Re:H06-0372-21 & H06-0772-19: Erection of Dwelling In Association With Existing Plant Hire Business: Contaminated Land – Supplemental Ground Gas Risk Assessment.

Location: Tilsons Yard, Black Barn, Gedney Drove End.

0665-L1 Comments [SHDC Planning Portal] SHDC Environmental Health Tilsons Yard, Black Barn, Gedney Drove End PE12 9PA for Mr & Mrs Parnell.

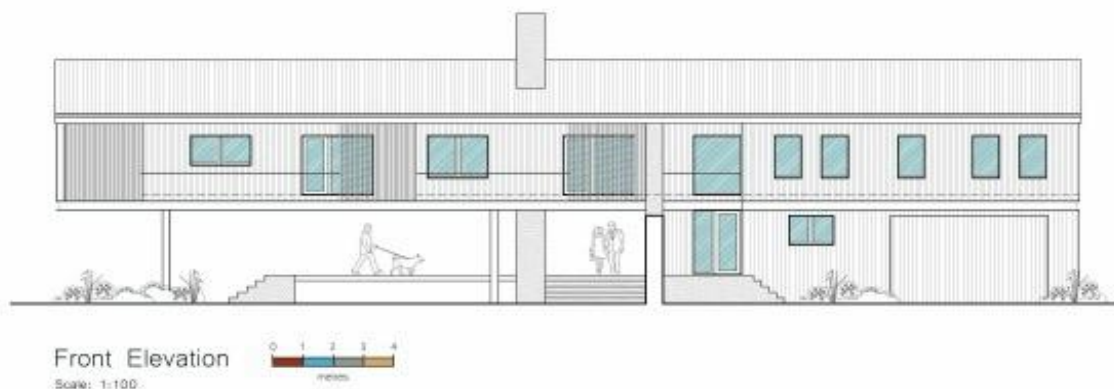
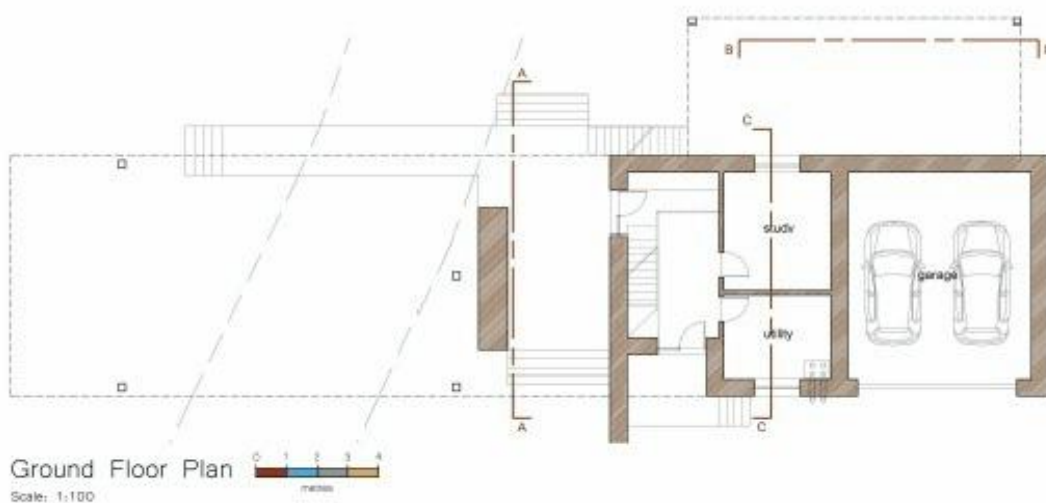
The proposed residential development comprises a single dwelling, which, due to flood risk matters will have minimal ground floor accommodation i.e. predominantly first floor living with bedrooms and living areas **raised** to first floor level [anecdotally] understood to be by 'a least a metre'. The significance of this is that much of the footprint of the dwelling will not be in contact with the [potentially] ground gas bearing soils. Discussion with the Architect suggested that this **raised area will comprise approximately 75%** of the building footprint **leaving only [approximately] 25% in contact with the ground**, and this 25% will have minimal occupancy. The following [Third Party] images have been taken from the Design & Access Statement obtained from the SHDC Planning Portal to illustrate this aspect of the proposed development.

The following two images have been included to assist the Reader and illustrate more clearly the 'ground contact' area of the proposed building. It is understood that the ground contact area of the dwelling will accommodate a Utility Room and a Garage.

It is reasonably anticipated that the proposed ground gas protection measures for the new dwelling which comprise a ventilated subfloor void supporting the 25% of the footprint which is in contact with the ground and a membrane [datasheet and installers

accreditation details provided at Appendix 2] which will be extended across the cavities and sealed into the DPC thus sealing out the internal spaces of this part of the building will achieve the precautionary position as suggested by SHDC on a site adjacent to a [closed] landfill and which this site is not, suggesting the application site is in a lower risk situation given the nature and consistency of the encountered ground conditions.

**Exploratory Location Plan
(Over Proposed Layout)**

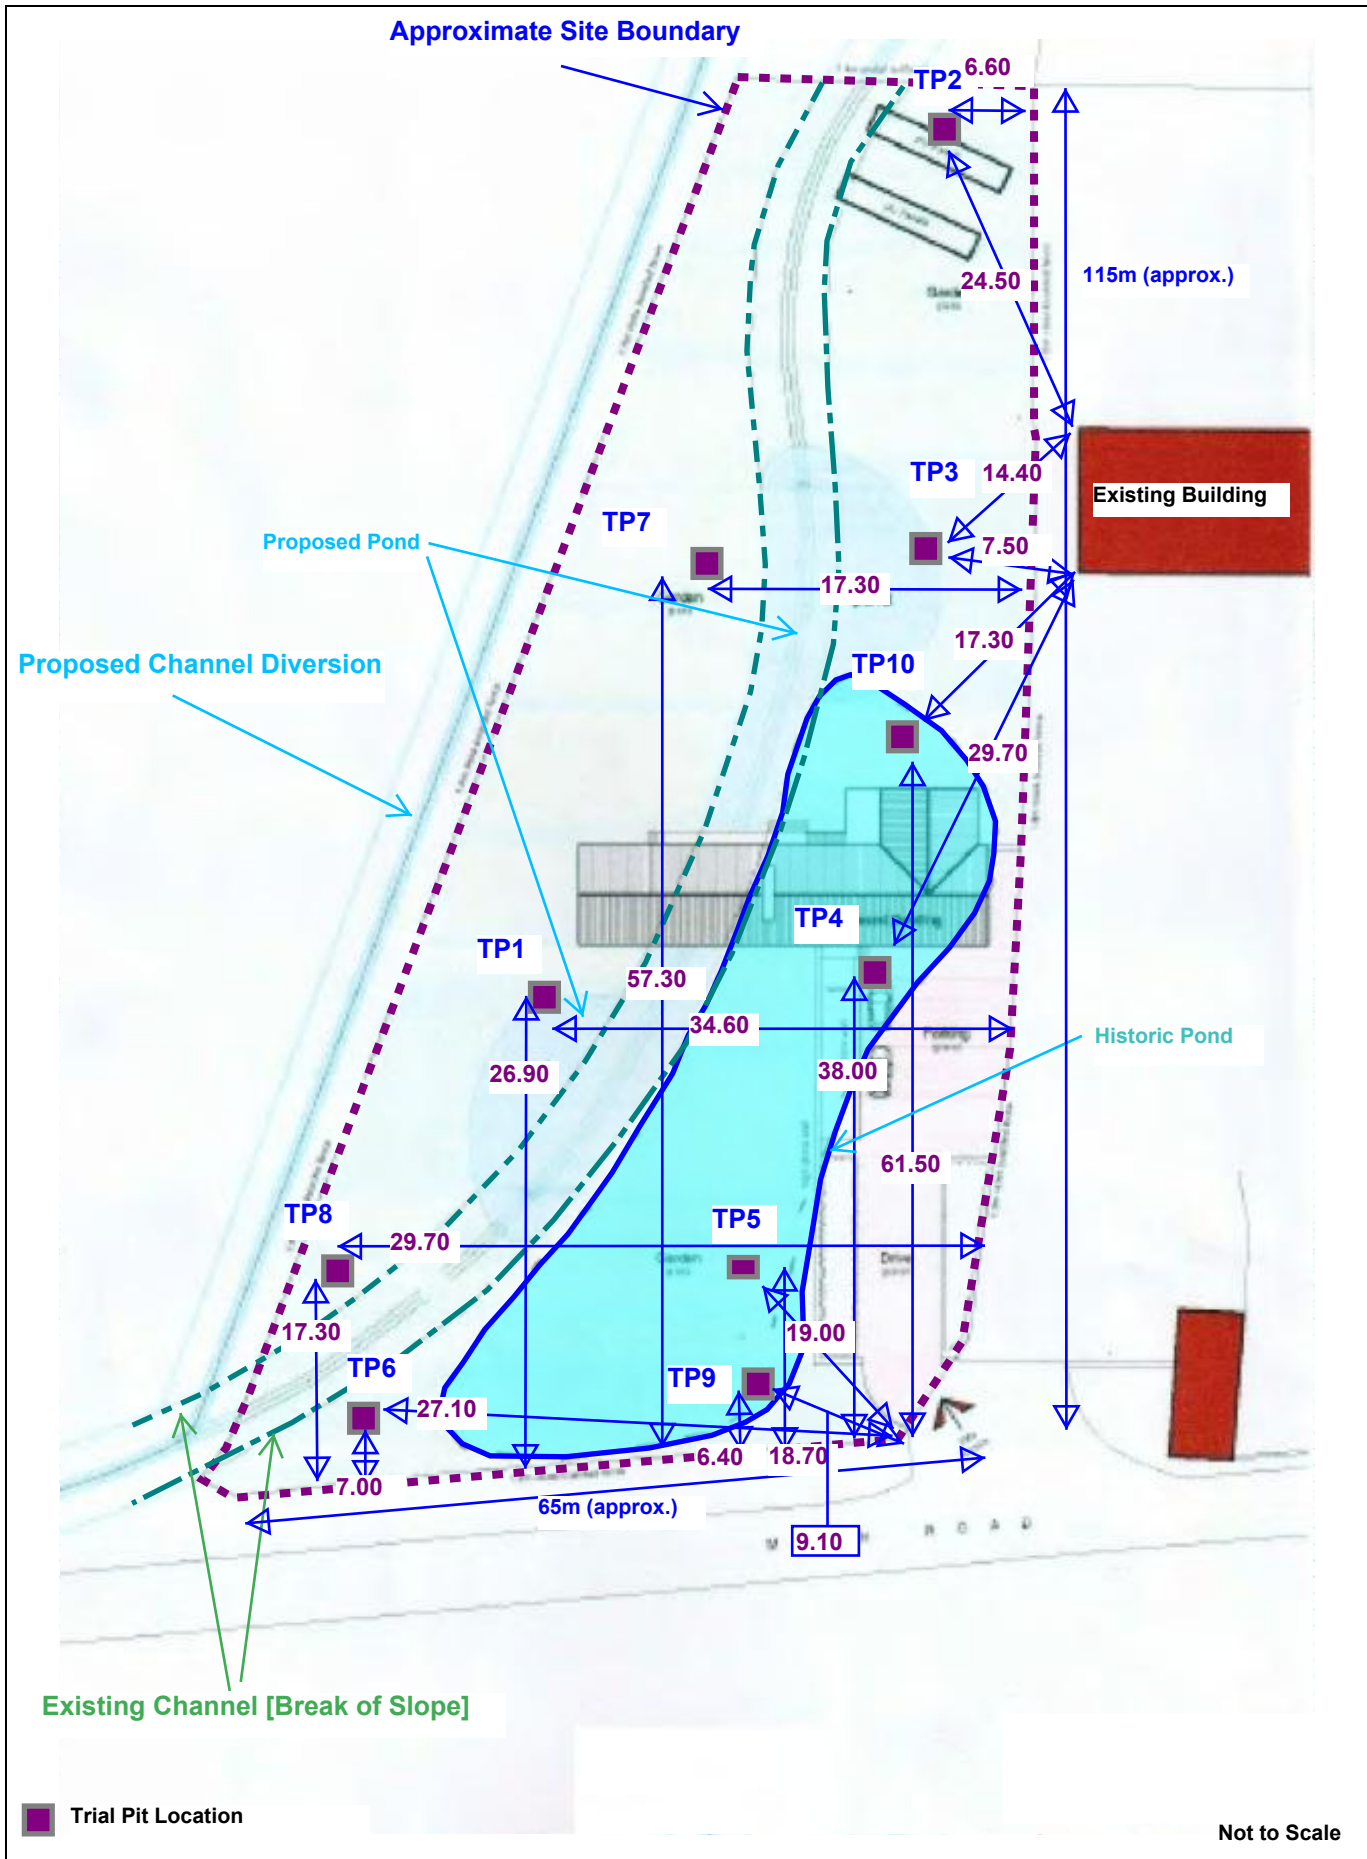
In this instance the referred images have been provided in Appendix 1, which accompanies this letter report. For the convenience of the Reader, the trial pit location plan from the Phase 2 Report has also been included to allow easy reference of the trial pit locations within the Application area.

A review of the available information showed that images for six of the ten trial pits were available and these have been presented against their respective logs in Appendix 1. Of the six records three were located within the pond area and three were outside the pond area and all six were well distributed across the site in terms of the 'area of concern'. Trial pits TP1, TP2, TP3 and TP5 were not photographed based upon the consistency [similarity] of the soil type encountered at the time of the fieldwork. There was no evidence of anthropogenic inclusions in the arising soils in any of the trial pits to suggest these soils could be considered to be anything other than indigenous soils rather than 'Made Ground'.
